Planning Commission

Staff Report

Case No:	16ZONE1058
Request:	Change in zoning from R-7 to OR
Project Name:	Eastern Parkway Law Office
Location:	604 Eastern Parkway
Owner:	Venture 604, LLC
Applicant:	C.R.P and Associates, LLC
Representative:	Randall L. Wright
Jurisdiction:	Louisville Metro
Council District:	15 - Butler
Case Manager:	Brian Mabry, AICP, Planning & Design Supervisor

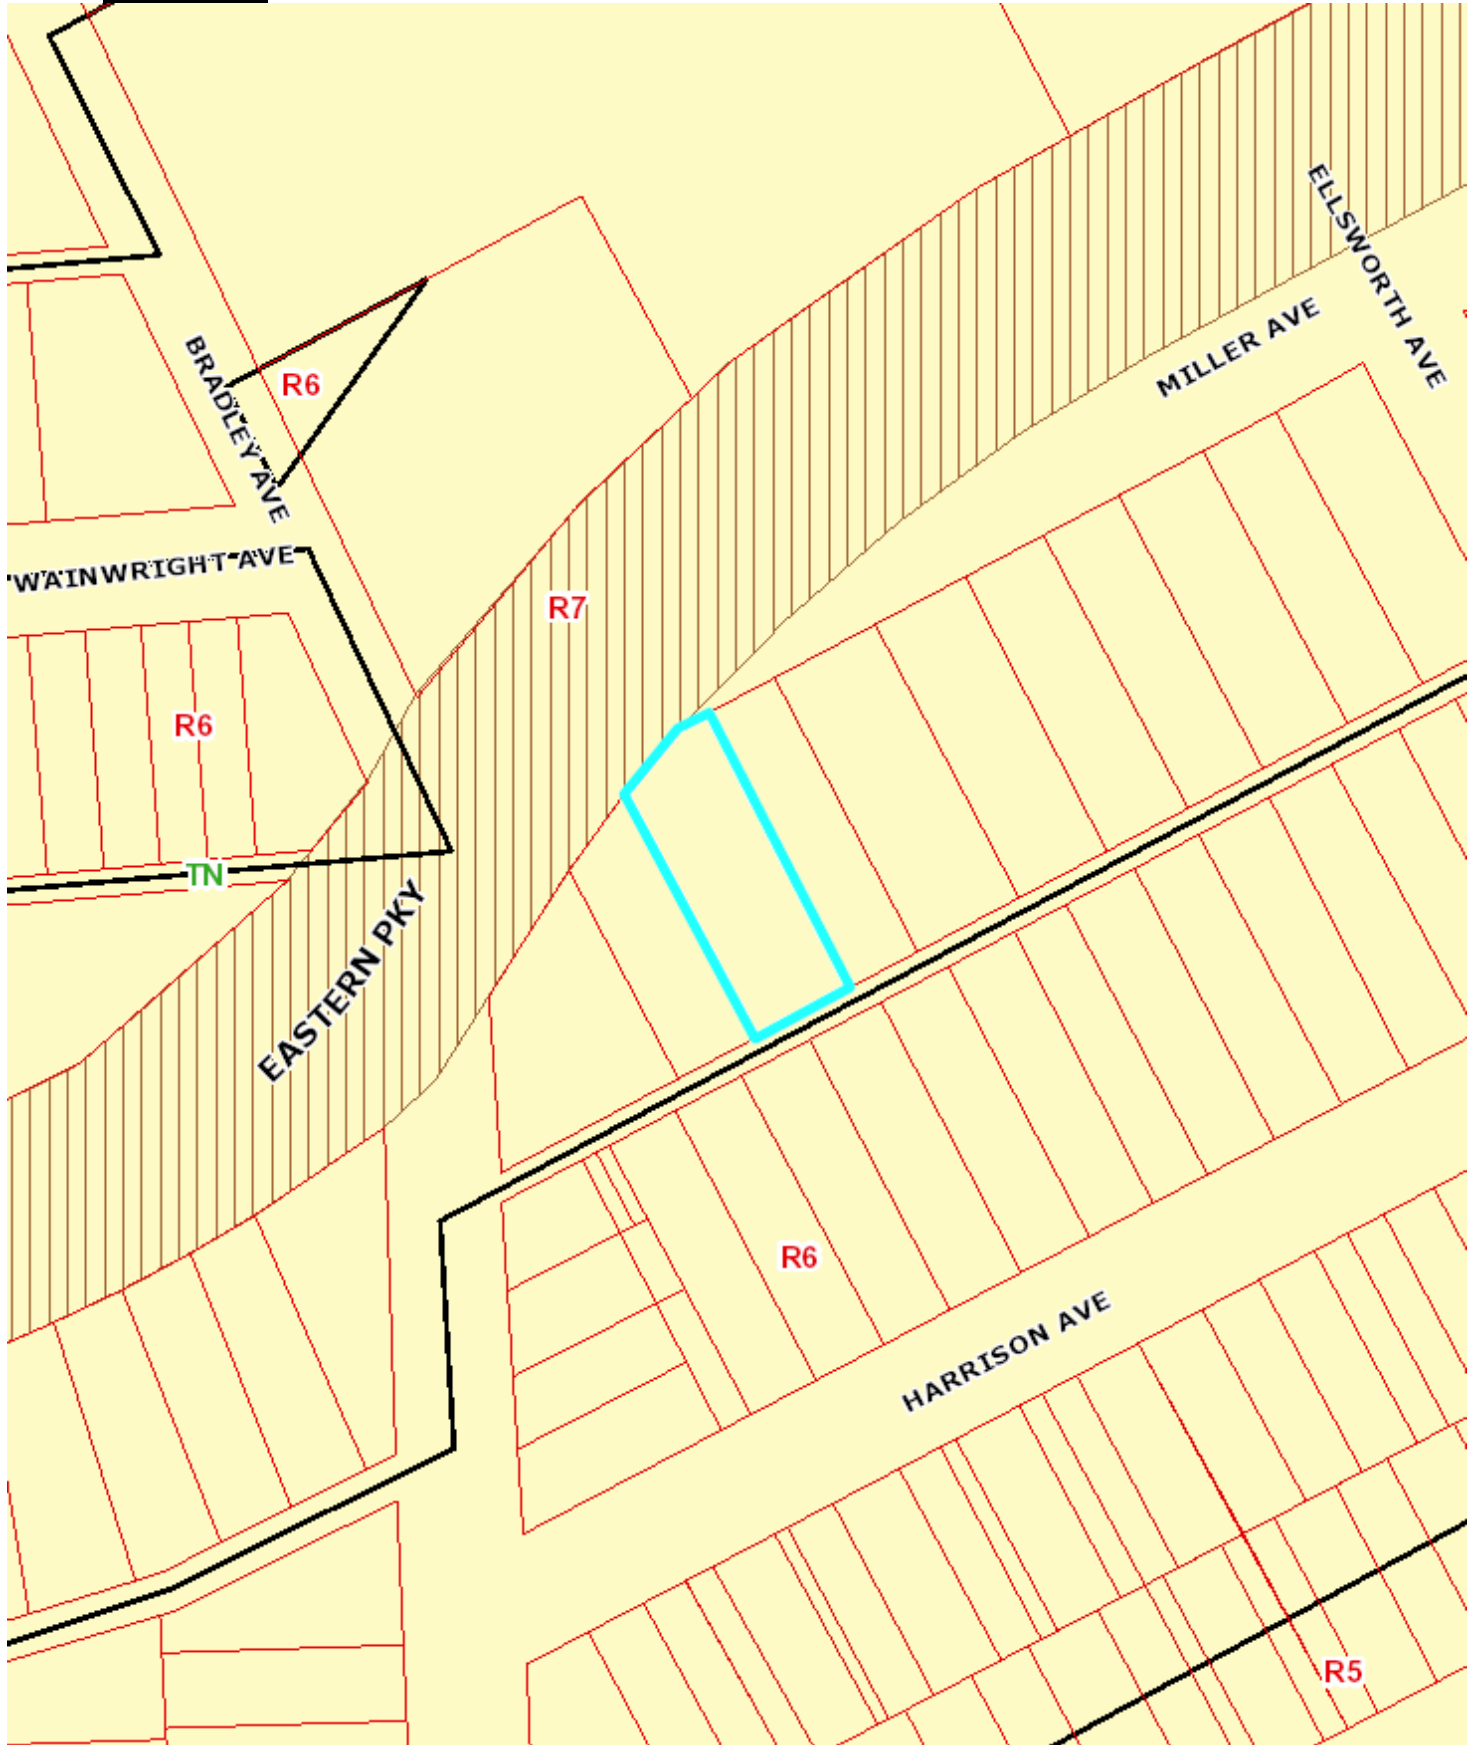
STAFF: The overall site design and land uses are compatible with the existing and future development of the area. Except for the portions of the LBA that will be encroached upon by the existing garage and the proposed off-street parking, appropriate landscape buffering and screening will be provided to screen adjacent properties and roadways.

STAFF: The waiver will not adversely affect adjacent property owners since the existing structure will remain on-site with screening added along the majority of the east and west property lines, except for where the existing detached garage and proposed parking area encroach.

STAFF: The extent of the waiver of the regulation is the minimum necessary to afford relief to the applicant to fit the minimum off-street parking on-site and to allow the existing detached garage to remain.

STAFF: The strict application of the provisions of the regulation would deprive the applicant of the reasonable use of the land or would create an unnecessary hardship on the applicant by eliminating existing parking below the minimum parking requirement and by forcing the removal of a brick detached garage.
